### **ADDENDUM No. 7** **Published March 5, 2021**

# ADDENDUM No. 7

## TO THE CITY OF FRESNO

### PUBLIC WORKS STANDARD DRAWINGS AND SPECIFICATIONS

CITY OF FRESNO  
ITS-27B

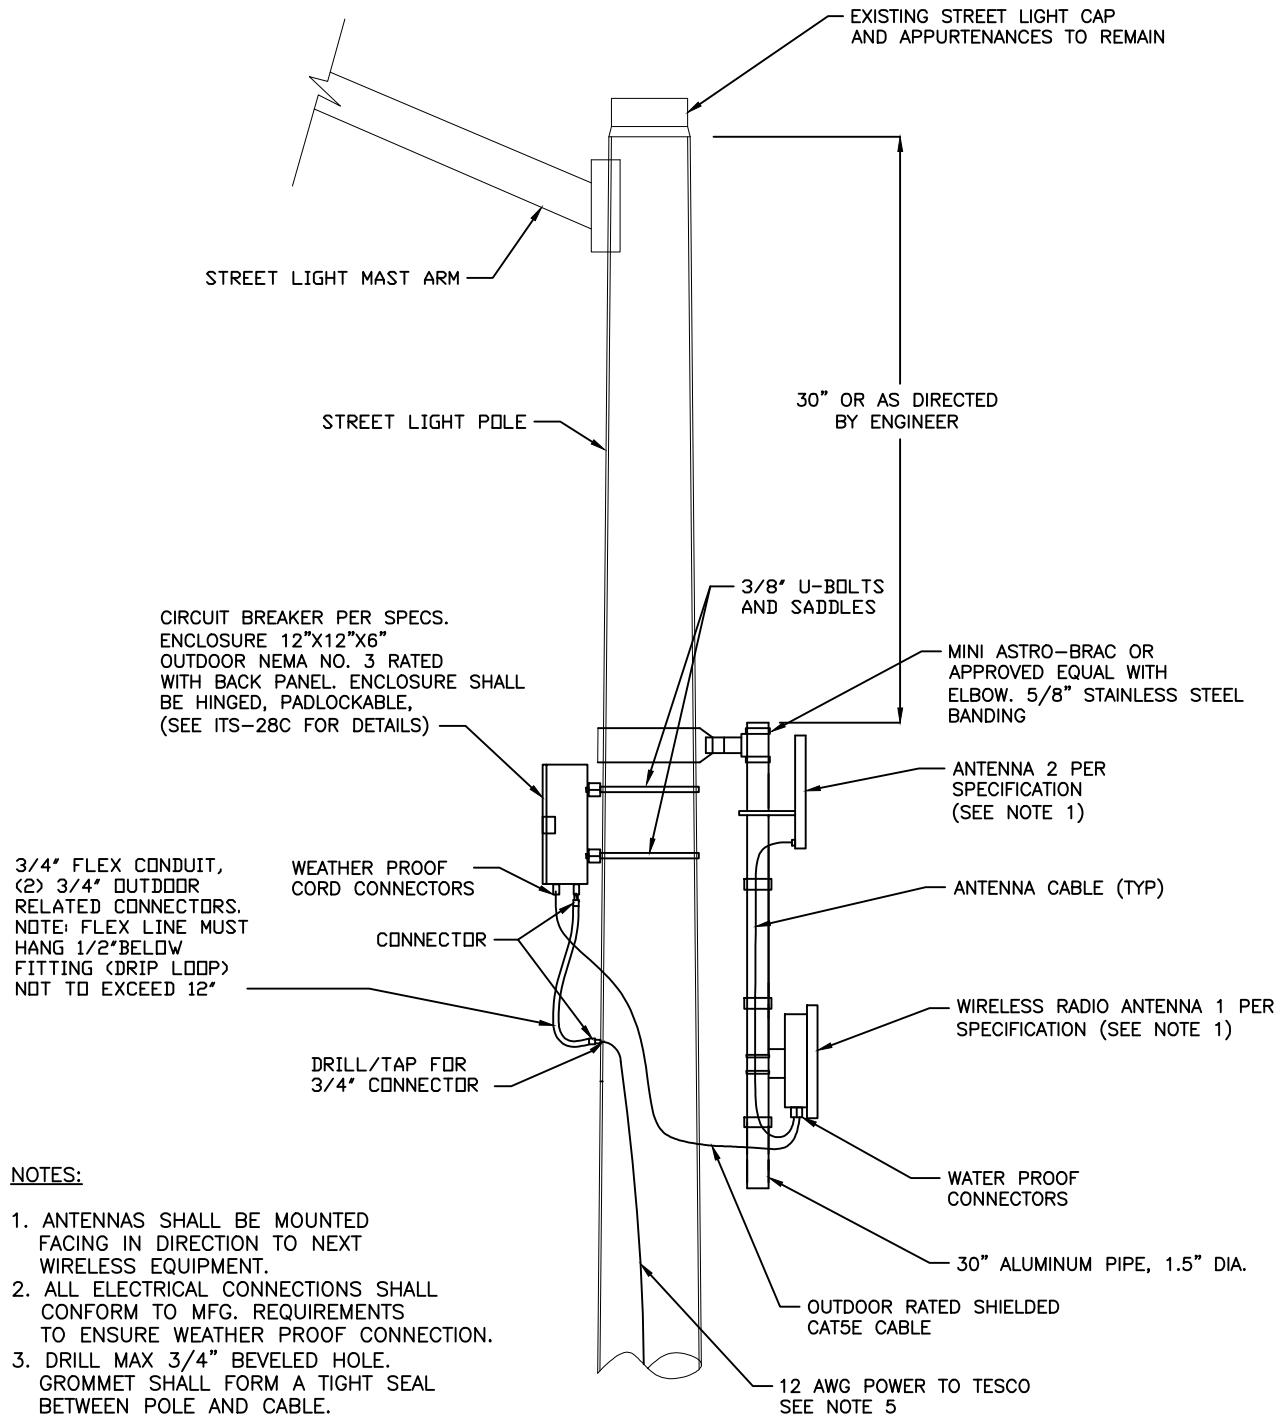
<b>ITS-27B</b>	<ol style="list-style-type: none"> <li>1. <b>Added callout:</b> "2' TYP"</li> <li>2. <b>Callout:</b> "16"-LONG, 1.5" DIAMETER ALUMINUM PIPE" <b>Revised to read:</b> "8"-LONG, 1.5" DIAMETER ALUMINUM PIPE"</li> <li>3. <b>Callout:</b> "4' ANTENNA CABLE (TYP)" <b>Revised to read:</b> "2-4' ANTENNA CABLES, SEE NOTE 5"</li> <li>4. <b>Callout:</b> "8"-LONG, 1.5" DIAMETER ALUMINUM PIPE" <b>Revised to read:</b> "16"-LONG, 1.5" DIAMETER ALUMINUM PIPE"</li> <li>5. <b>Added callout:</b> "DRIP LOOP"</li> <li>6. Antenna 1 <b>drawing revised</b> to depict integrated antenna with wireless access point</li> <li>7. <b>Removed callout:</b> "ANTENNA 1 (BACK)"</li> <li>8. <b>Callout:</b> "WIRELESS ACCESS POINT" <b>Revised to read:</b> "WIRELESS ACCESS POINT ANTENNA 1 BACK"</li> <li>9. <b>Callout:</b> "MINI ASTRO-BRAC OR APPROVED EQUAL WITH ELBOW" <b>Revised to read:</b> "MINI ASTRO-BRAC OR APPROVED EQUAL WITH NO ELBOW"</li> <li>10. <b>Added callout:</b> "CAT5e DRIP LOOP"</li> <li>11. <b>Added callout:</b> "ANTENNA 2"</li> <li>12. <b>Added callout:</b> "8"-LONG, 1.5" DIAMETER ALUMINUM PIPE"</li> <li>13. <b>Callout:</b> "2' ANTENNA CABLE (TYP)" <b>Revised to read:</b> "2-4' ANTENNA CABLES (TYP)"</li> <li>14. <b>Callout:</b> "WIRELESS ACCESS POINT" <b>Revised to read:</b> "WIRELESS ACCESS POINT ANTENNA 1"</li> <li>15. <b>Callout:</b> "MINI ASTRO-BRAC OR APPROVED EQUAL WITH ELBOW" <b>Revised to read:</b> "MINI ASTRO-BRAC OR APPROVED EQUAL"</li> <li>16. <b>Note 2:</b> "ANTENNA 2 MOUNTING IS SIMILAR TO THAT SHOWN IN THE CROSS SECTION ABOVE, BUT NO HOLES ARE DRILLED IN THE MAST ARM, AN 8'-LONG ALUMINUM PIPE IS USED, AND ACCESS POINT IS NOT INSTALLED, AND THE MINI ASTRO-BRAC IS INSTALLED ON TOP OF THE MAST ARM WITH NO ELBOW." <b>Revised to read:</b> "ANTENNA 2 MOUNTING IS SIMILAR TO THAT SHOWN IN THE CROSS SECTION ABOVE, BUT NO HOLES ARE DRILLED IN THE MAST ARM, A 16"-LONG ALUMINUM PIPE IS USED, AN ACCESS POINT IS NOT INSTALLED."</li> </ol>

<p>17. <b>Note 4:</b> "ANTENNA 2 WILL BE MOUNTED IN THE SAME DIRECTION AS ANTENNA 1 WHEN IT IS THE LAST ACCESS POINT IN RUN." <b>Revised to read:</b> "ANTENNA 1 AND ANTENNA 2 SHALL HAVE A MINIMUM 2' OF SEPERATION."</p> <p>18. <b>Added Note 5:</b> "SECURELY STRAP ANTENNA CABLE TO MAST ARM WITH STAINLESS STEEL NYLON COATED STRAPS (FOLLOW NEC STANDARD FOR SPACING."</p> <p>19. <b>Added Note 6:</b> "ALL ELECTRICAL CONNECTIONS SHALL CONFORM TO MANUFACTURER REQUIREMENTS TO ENSURE WEATHER PROOF CONNECTIONS."</p>
<b>ITS-28B</b>	<p>1. <b>Callout:</b> "WIRELESS RADIO PER SPECIFICATION" <b>Revised to read:</b> "WIRELESS RADIO ANTENNA 1 PER SPECIFICATION (SEE NOTE 1)"</p> <p>2. Antenna 1 <b>drawing revised</b> to depict integrated antenna with wireless access point</p> <p>3. <b>Removed callout:</b> "ANTENNA 1 PER SPECIFICATION (SEE NOTE 1)"</p> <p>4. <b>Added callout:</b> "OUTDOOR RATED SHIELDED CAT5E CABLE"</p> <p>5. <b>Callout:</b> "12 AWG POWER TO TESCO" <b>Revised to read:</b> "12 AWG POWER TO TESCO SEE NOTE 5"</p> <p>6. <b>Removed callout:</b> "SEE NOTE 5"</p> <p>7. <b>Added Note 7:</b> "POLE HANDHOLE SHALL BE WELDED IN PLACE AFTER ALL PROPOSED WORK IS COMPLETED AND INSPECTED ON STREET LIGHT POLE. CONTRACTOR SHALL PROTECT CONDUCTORS FROM DAMAGE DURING WELDING."</p>

CITY OF FRESNO  
RW-9

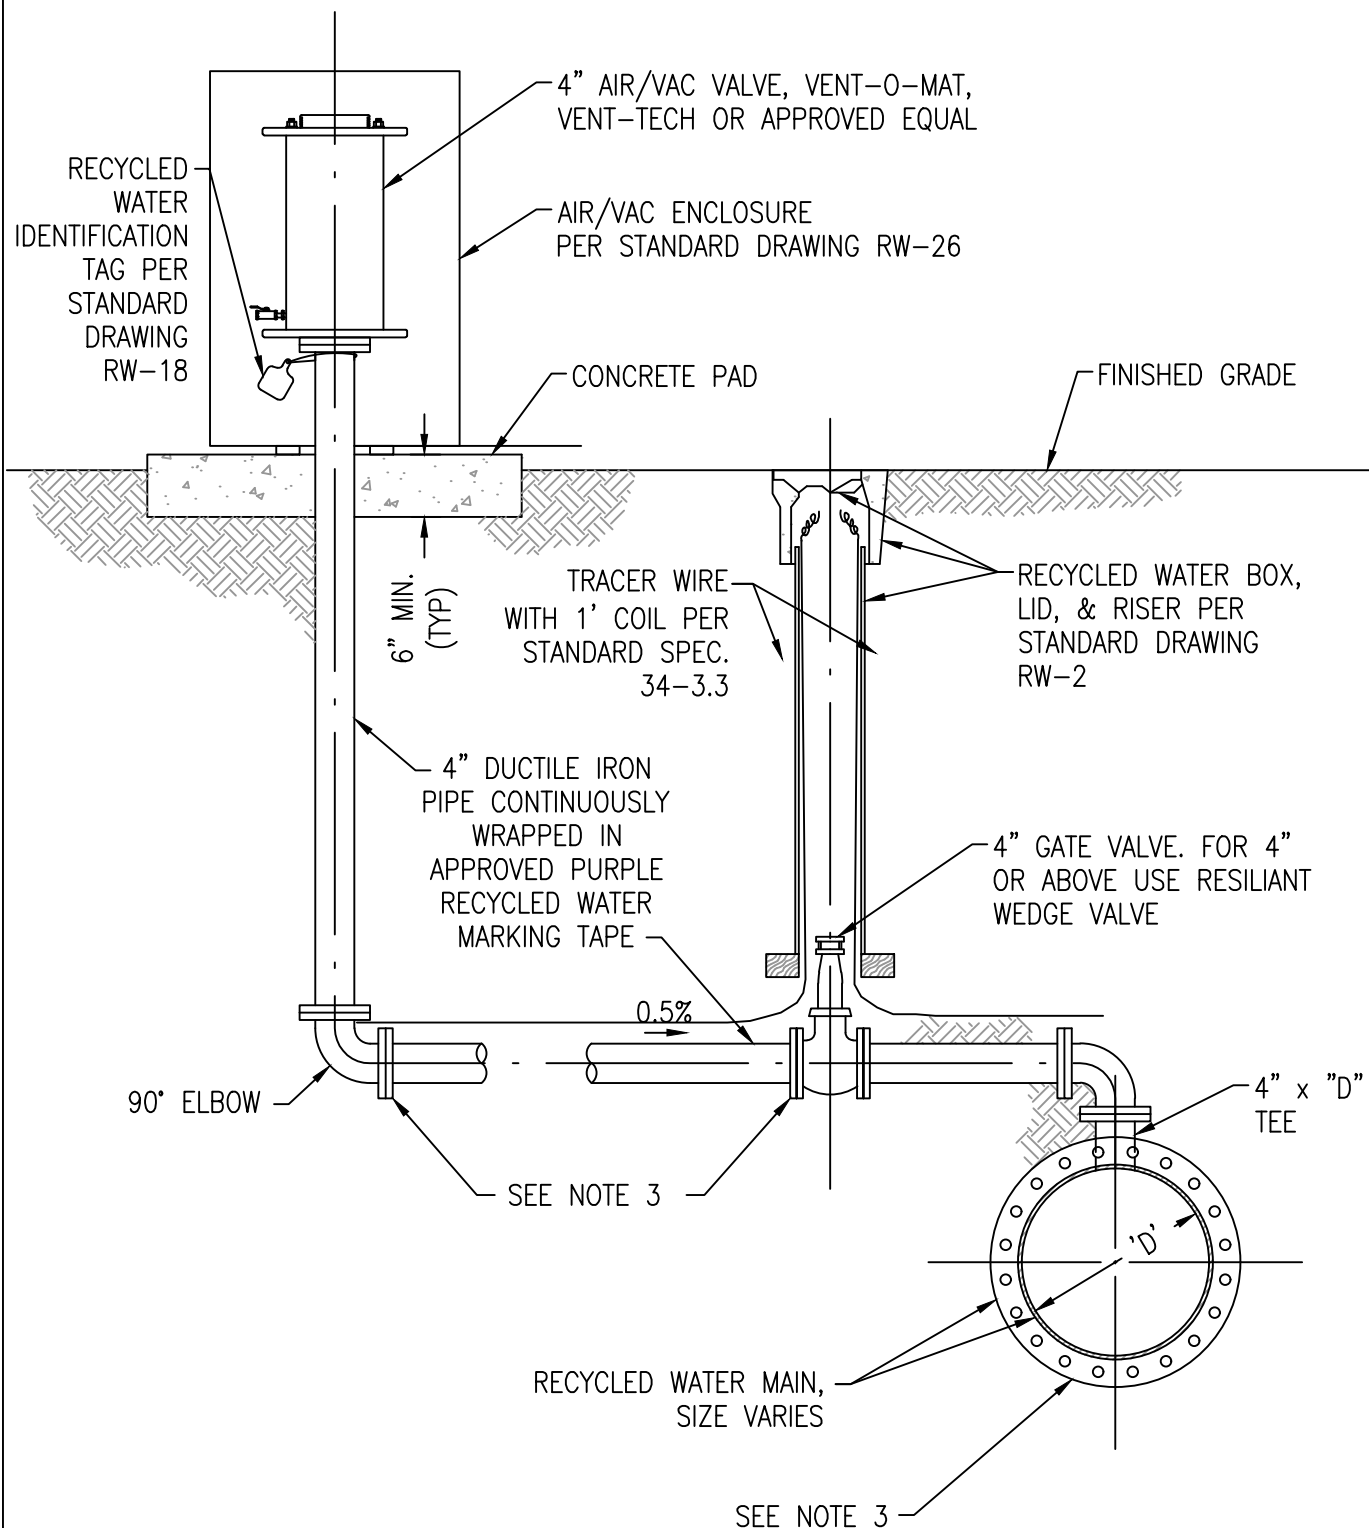
6. Tracer wire relocated to inside the riser barrel.
<b>RW-8B</b>	1. <b>New Standard Drawing:</b> "RECYCLED WATER BLOW-OFF ASSEMBLY (STEEL MAIN)"
<b>RW-9</b>	<ol style="list-style-type: none"> <li>1. <b>Drawing title:</b> "RECYCLED WATER 1" OR 2" AIR RELEASE/VACUUM BREAKER STATION" <b>Revised to read,</b> "RECYCLED WATER 1" OR 2" AIR RELEASE/VACUUM BREAKER ASSEMBLY"</li> <li>2. <b>Callout(s),</b> "1" OR 2" COPPER 90° ELBOW, LONG RADIUS, 95-5 SOLDER JOINTS, 0-300 PSI" <b>Revised to read:</b> "1" OR 2" COPPER 90° ELBOW, LONG RADIUS, 95-5 PACK JOINT CONNECTIONS FOR (CTS) TUBING, 0-300 PSI"</li> <li>3. <b>Callout,</b> "1" OR 2" COPPER COUPLING WITH STOPS, 95-5 COPPER SOLDER JOINTS, 0-300 PSI" <b>Revised to read:</b> "1" OR 2" COPPER COUPLING WITH STOPS, 95-5 PACK JOINT CONNECTIONS FOR (CTS) TUBING, 0-300 PSI"</li> <li>4. <b>Callout,</b> "1" OR 2" COPPER ADAPTER, SOLDER JOINT BY MALE IPT, 0-300 PSI" <b>Revised to read:</b> "1" OR 2" COPPER ADAPTER, PACK JOINT CONNECTIONS FOR (CTS) TUBING, 0-300 PSI"</li> <li>5. <b>Callout,</b> "TRACER WIRE WITH 1' COIL, PER STANDARD SPEC. 22-3.3" <b>Revised to read:</b> "TRACER WIRE WITH 1' COIL PER STANDARD SPEC. 34-3.3"</li> <li>6. <b>Callout,</b> "AIR/VAC ENCLOSURE PER STANDARD DRAWING RW-11" <b>Revised to read:</b> "AIR/VAC ENCLOSURE PER STANDARD DRAWING RW-26"</li> <li>7. <b>Callout added:</b> "RECYCLED WATER BOX, LID, &amp; RISER PER STANDARD DRAWING RW-2"</li> <li>8. <b>Drawing Revised:</b> limits of concrete pad expanded to incorporate water valve.</li> <li>9. <b>Drawing Revised:</b> water valve added to drawing.</li> <li>10. <b>Removed dimension:</b> "2' MIN" (located between saddle tap and copper coupling)</li> <li>11. <b>Added dimension:</b> "2' MAX" (located between water valve and air/vac valve)</li> <li>12. <b>Note 3:</b> "RESTRAIN ALL JOINTS PER SITY STANDARD SPECIFICATIONS SECTION 21-15.5" <b>Revised to read,</b> "RESTRAIN ALL JOINTS PER SITY STANDARD SPECIFICATIONS SECTION 33-14.5"</li> <li>13. Tracer wire relocated to inside the riser barrel.</li> </ol>
